Subject: River-Golf Course PAAEA and draft EIR/EIS/EIS for Upper Truckee River Restoration and Golf Course Reconfiguration Project

Review of ‘Upper Truckee River Restoration and Golf Course Reconfiguration Project’

Comments submitted to the California Department of Parks and Recreation on the proposed golf course reconfiguration and channel reconstruction project described in the ‘Preferred Alternative 2B and Additional Environmental Analysis’ and other volumes of the EIS/EIR.

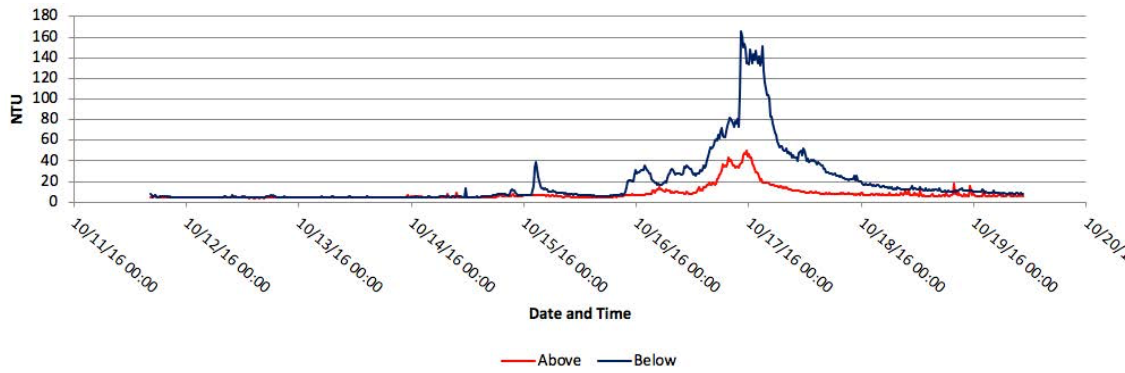
While the amounts eroded from the construction access road and other potential sources areas in Reach 5 have not been quantified by surveys, we are fortunate to have data from continuously-recording turbidity meters upstream and downstream of the Reach 5 project. There were multiple high flows over the 2016-2017 winter-spring flow season. Data for the first major storm, 16-18 October 2016, indicate significant increases in turbidity below Reach 5 (Figure 2).

These turbidity values can be converted into suspended sediment concentrations using a relation presented by Second Nature (2011, Figure 8), and then the concentrations can be multiplied by flow to yield total load, which can be summed over the course of the flood to yield total load above the reach and total load below. We have not undertaken this exercise, but the striking increase in turbidity downstream suggests large fine-sediment sources were accessed in between the two measurement stations. All the stormflows of the 2016-2017 year (and the 2017-2018 year as well), should be subject to the same analysis, to see in which storms the reach in between the turbidity gauges was a net sink, and in which it was a net source of sediment. The relative contributions to this increased load from erosion of the access road and other areas exposed due to construction disturbance, erosion of other floodplain areas, bank erosion, and upland erosion would need to be explored further to better understand the specific sediment sources in Reach 5.

The value of such turbidity data for assessing performance of the proposed Washoe Meadows project in meeting its principal objective, to “reduce the river’s discharge of suspended sediments into Lake Tahoe,” is obvious. The EIS/EIR and related documents for the Washoe Meadows reach do not provide details regarding the monitoring to be undertaken, but a commitment to adequate monitoring of project effectiveness should include establishment of an additional continuously-recording turbidity meter upstream of the Washoe Meadows project to allow for comparison of turbidity, and thus modeled concentrations and calculated loads up and downstream. The turbidity gauge should begin operating prior to the project construction to provide baseline data to inform interpretations of patterns observed during and after project construction.
